VALUE ENGINEERING TEAM STUDY
AA

Value Engineering Study on the

NAPA RIVER

FLOOD CONTROL PROJECT

TYPICAL SHEET PILE CHANNEL WALL AND BENCH REACH

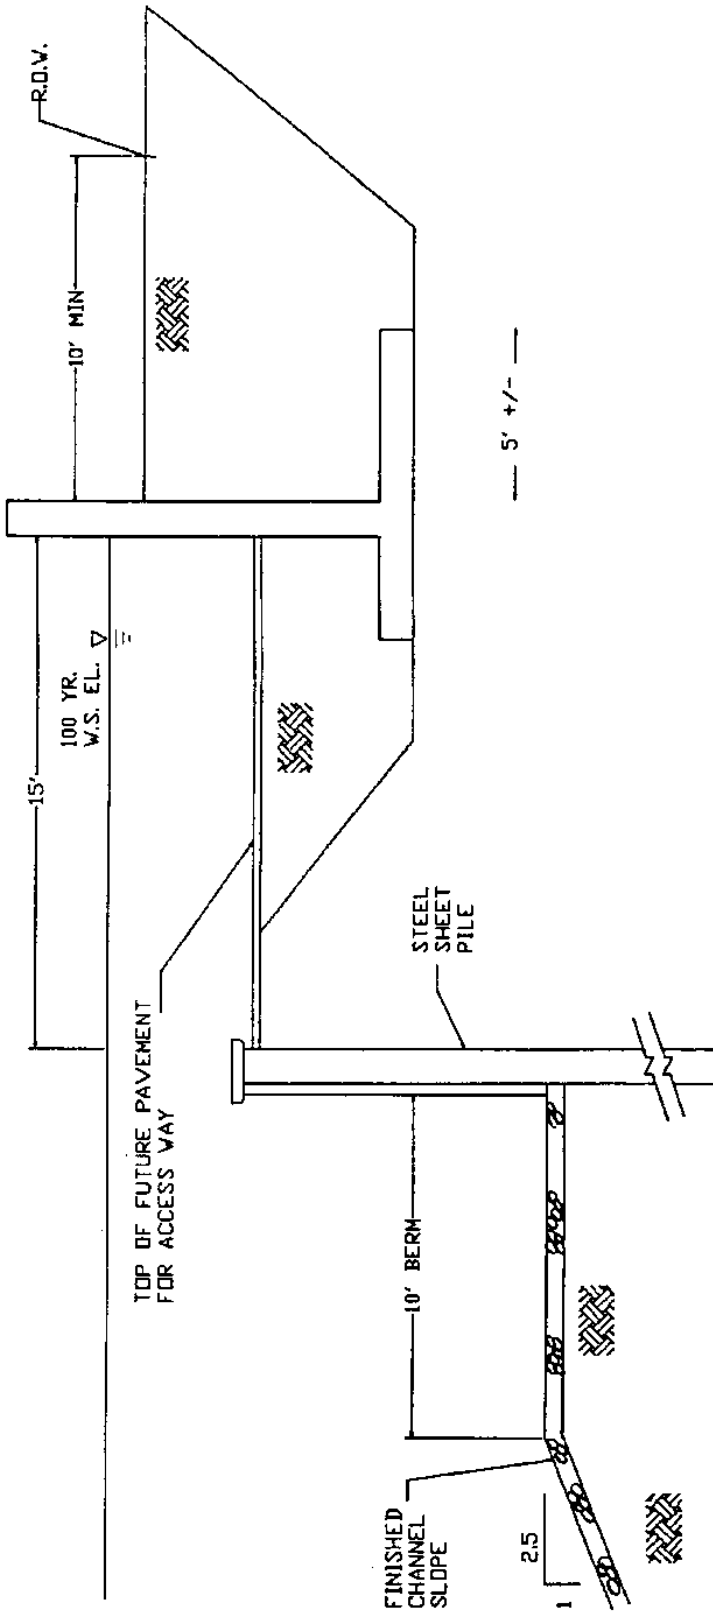
ORIGINAL DESIGN: The current design provides 174,700 SF of PZ-40 and 32,400 SF of PZ-27 steel sheet pile for retaining walls along approximately 3,400 LF of the Napa River. Exposed walls are two heights - 8 1/2 and 14 feet. Depths are estimated to vary to 40 feet. The typical sections feature a simple I-Wall channel wall from Pine to Fifth Streets (Station 220+00 to Station 251+00), and a shorter wall as part of the bench wall system at Fifth to Third Streets (Station 251+00 to Station 256+00).

PROPOSED DESIGN: It is recommended the option be provided to allow both hot and cold formed steel sheet pile if design conditions are met by both products. Cold formed CZ sections provide two options for the PZ-27. CZ 128 has a section modulus of 35.34 cu. in./LF with a weight advantage of 26.2 (vs. 27 #/SF for PZ-27). CZ 114 has a section modulus of 31.62 with a weight advantage of 23.4 vs. 27 #/SF (saves 3.6 #/SF). It was recommended the designers revisit the requirement for the wall sections currently shown as PZ-40. If the walls can be designed to PZ-35, based on complete project soils data when available, a cold formed section can be used. CZ 148 has a section modulus of 40.92, exceeding the PZ-35 section, and a weight advantage of 30.3 vs. 35 #/SF. Where both materials are specified based on performance to project conditions, competition in bidding will be improved. CASTEEL has over 10 years in production in Canada (has been in the U.S. 3 years), and has furnished products to Corps project in several areas in the U.S. See Appendix G for supporting data. Prices for materials delivered on site were given as follows:
